BASES  
BACKGROUND

**ADDITIONAL INFORMATION COVER SHEET**

**Comment:** Provide one DOC for each LCO to justify CTS changes that involve reformatting or word differences without any change in meaning or operation of the plant.

**FLOG RESPONSE:** As discussed in the transmittal letter and the "Methodology For Mark-Up of Current TS" in the back of Enclosure 2, the CTS has been marked up to reflect the substance of NUREG-1431, Revision 1. In general, only technical changes have been identified. However, some non-technical changes have also been included when the changes cannot easily be determined to be non-technical by a reviewer, or if an explanation is required to demonstrate that the change is non-technical. DOC 1-63-A was created and added to the top of the page for each CTS Section 3.3 Specification. DOC 1-63-A states:

J.1 and J.2

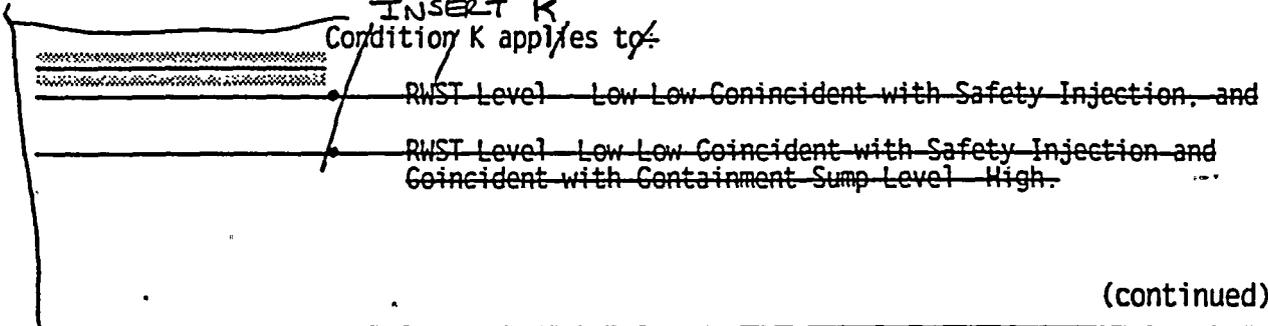
~~NOT USED~~ INSERT ACTION J BARS Q 3.3-127

~~Condition J applies to the AFW pump start on trip of all MFW pumps.~~

J.1 and J.2

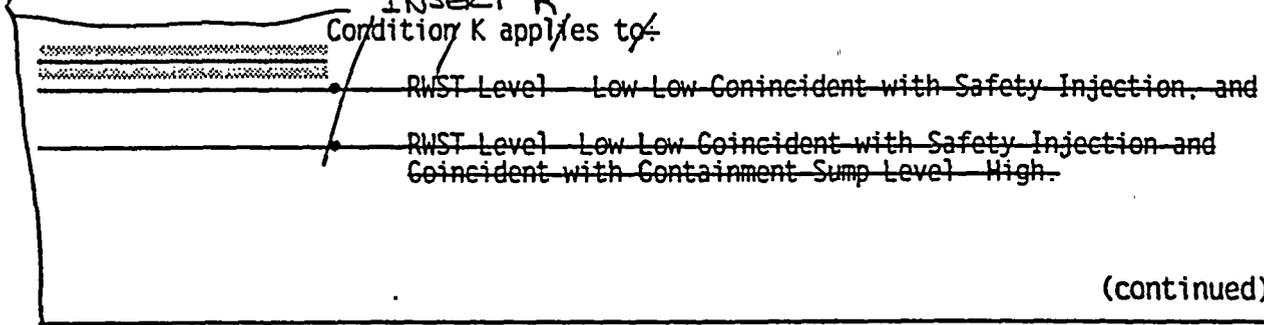
~~NOT USED~~ INSERT ACTION J BASES Q 3.3-127

~~Condition J applies to the AFW pump start on trip of all MFW pumps.~~

~~NOT USED~~ INSERT ACTION J BASES Q 3.3-127

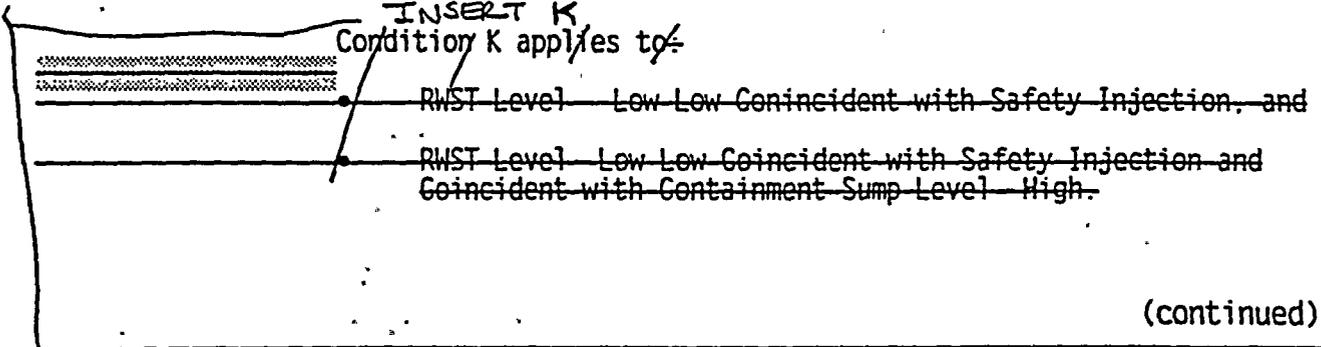
~~Condition J applies to the AFW pump start on trip of all MFW pumps.~~

~~This action addresses the train orientation of the SSPS for the auto start function of the AFW System on loss of all MFW pumps. The OPERABILITY of the AFW System must be assured by allowing automatic start of the AFW System pumps. If a channel is inoperable, 48 hours are allowed to return it to an OPERABLE status. If the function cannot be returned to an OPERABLE status, 6 hours are allowed to place the unit in MODE 3. The allowed Completion Time of 6 hours is reasonable, based on operating experience, to reach MODE 3 from full power conditions in an orderly manner and without challenging unit systems. In MODE 3, the unit does not have any analyzed transients or conditions that require the explicit use of the protection function noted above. The allowance of 48 hours to return the train to an OPERABLE status is justified in Reference 8.~~
